#### CITY OF FLORENCE DESIGN REVIEW BOARD OCTOBER 13, 2021 AT 2:00 P.M. AGENDA

#### DEPARTMENT OF PLANNING, RESEARCH & DEVELOPMENT STAFF REPORT TO THE CITY OF FLORENCE DESIGN REVIEW BOARD

CASE NUMBER:	DRB-2021-25
DATE:	October 13, 2021
LOCATION:	257 North Coit Street
TAX MAP NUMBER:	90073-05-005
<b>OWNER OF RECORD:</b>	Rabah Abudayya
APPLICANT:	Rabah Abudayya
PROJECT DESCRIPTION:	Request to install brick and change out windows
OVERLAY DISTRICT:	D-2 Downtown Central Overlay District and D-1 Redevelopment Overlay District

Attachment E: Proposed Façade Rendering

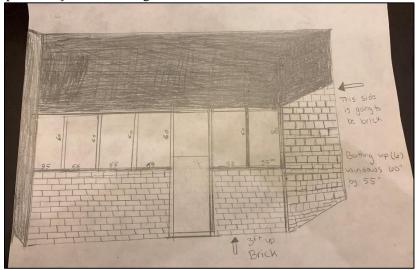
# Some of the prohibited materials like wooden clapboard siding and heavily textured stucco will be covered by the addition of the proposed brick façade. The applicant has stated the bricks chosen will be a traditional red brick. No samples have been provided at this time.

Attachment E: Renderings

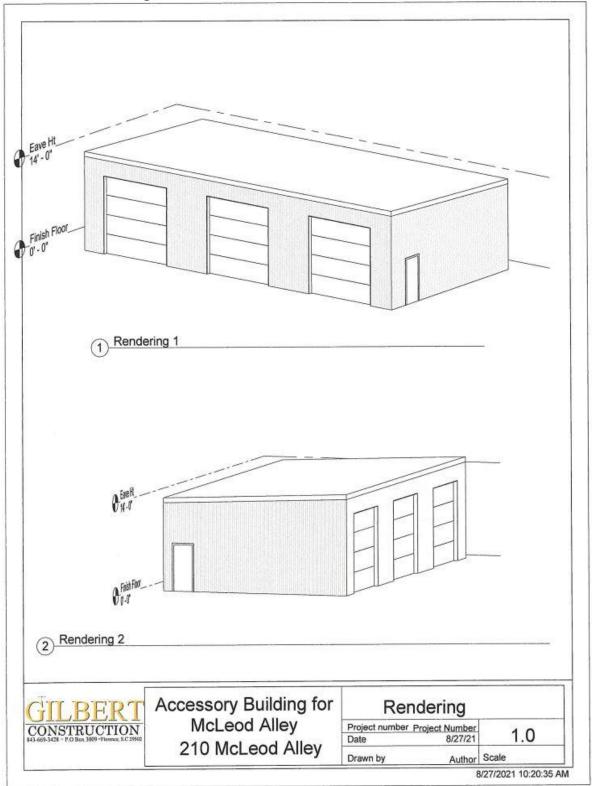
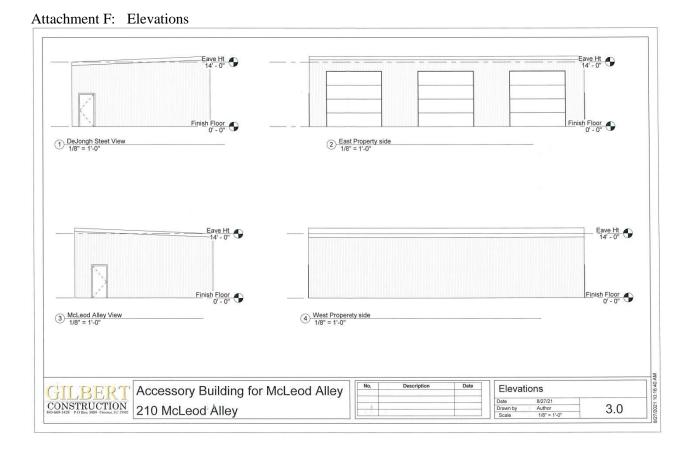
- 3. For all buildings, aluminum or vinyl siding may not be used unless approved by the Design Review Board; *The proposed new construction will be a steel building with Polar White wall and trim to complement the existing building that is has walls of light beige and trim of brown.*

- 9. The design of the roof should be compatible with the architectural style and character of existing buildings and surrounding structures; *The roof of the proposed metal building will be flat compared to the existing building which has a very gentle slope.*

- 11. The scale of buildings or structures after alteration, construction, or partial demolition should be compatible with the style and character of surrounding buildings and structures; *The proposed building will be of similar size and construction as the existing metal building.*
